SEWAGE DISPOSAL SYSTEM

MARYLAND STATE DEPARTMENT OF HEALTH

HOWARD COUNTY HEALTH DEPARTMENT

RE: **BP#** B00112638
2889 Florence Road

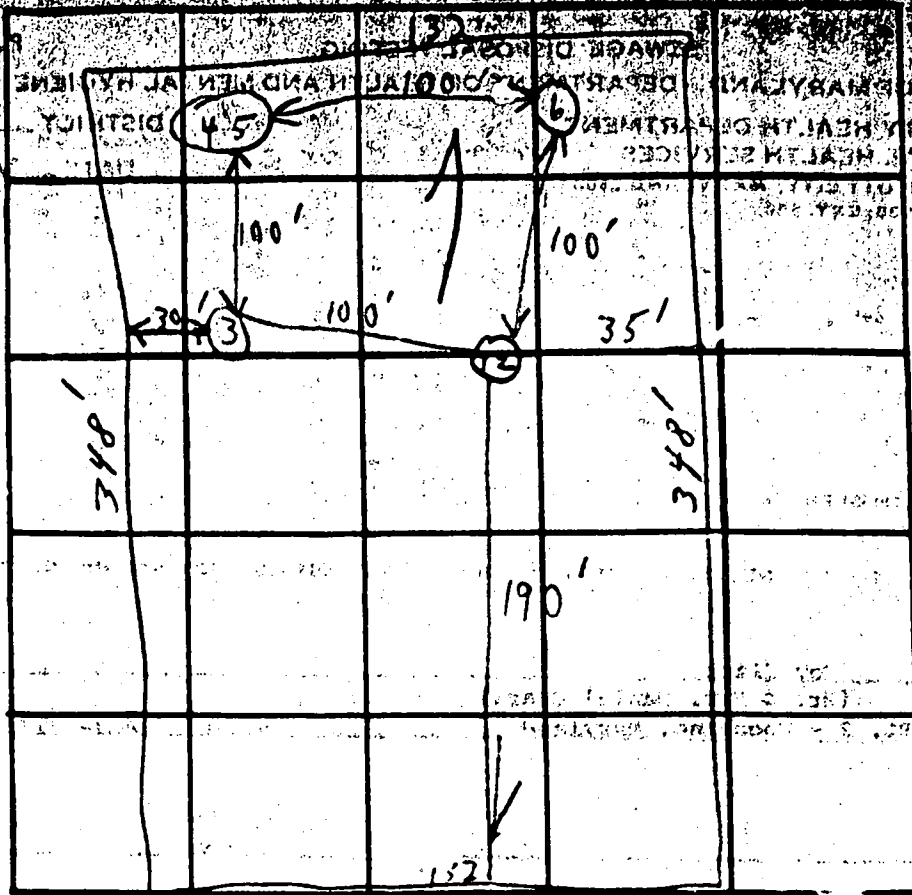
REMARKS 6/25/77 Needs cement seal around cast iron
to septic tank down house & reset Dr. Well
to get it done. (Took off to get permit)

Updated June 21, 1998
 Revisions NOT TO SCALE...

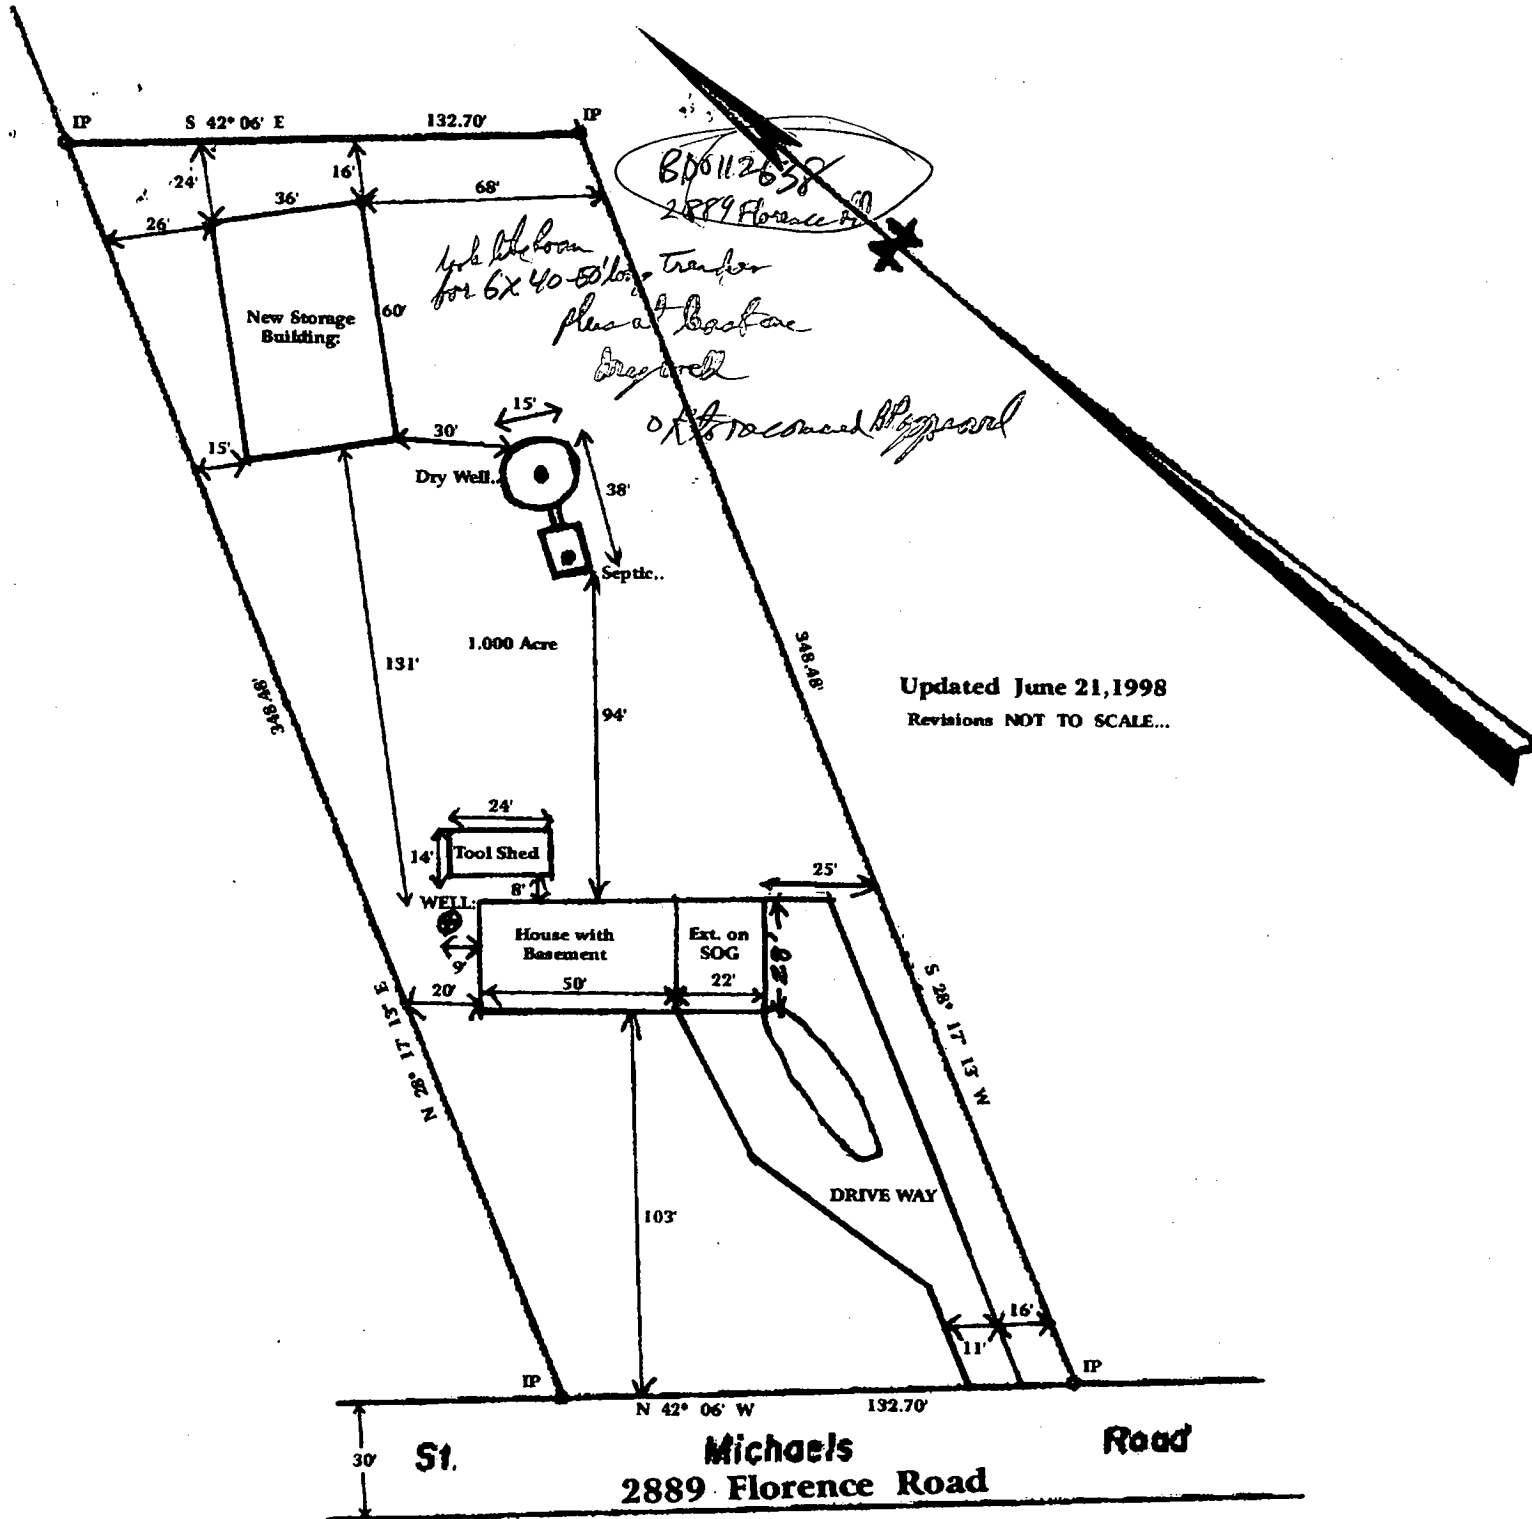
- No water supply has been established to serve the proposed dwelling. (Please submit a copy of the well completion report for review, along with a revised site plan showing actual well location.)
- No septic elevations have been provided on the site plan submitted.
- Incorrect septic specifications utilized in proposed septic system design. (See enclosure)
- No invert elevation(s) provided for: _____
- Proposed ~~house~~ ^{building addition} to _____ sewage disposal less than 20 feet.
- Existing well to _____ less than _____ feet.
- Sewage easement location/configuration incorrect. (See enclosure)
- Other: Plan must demonstrate suffucient reserve area for future septic system repairs. Additional percolation testing may be required. Contact the Health Department to discuss particulars of the plan.

Schedule for site inspection, then back here -

we discuss all well site, adequate septic repair area

Maybe a test hole (looking for shale) before final decision
or plan revision RFB 7/1/98
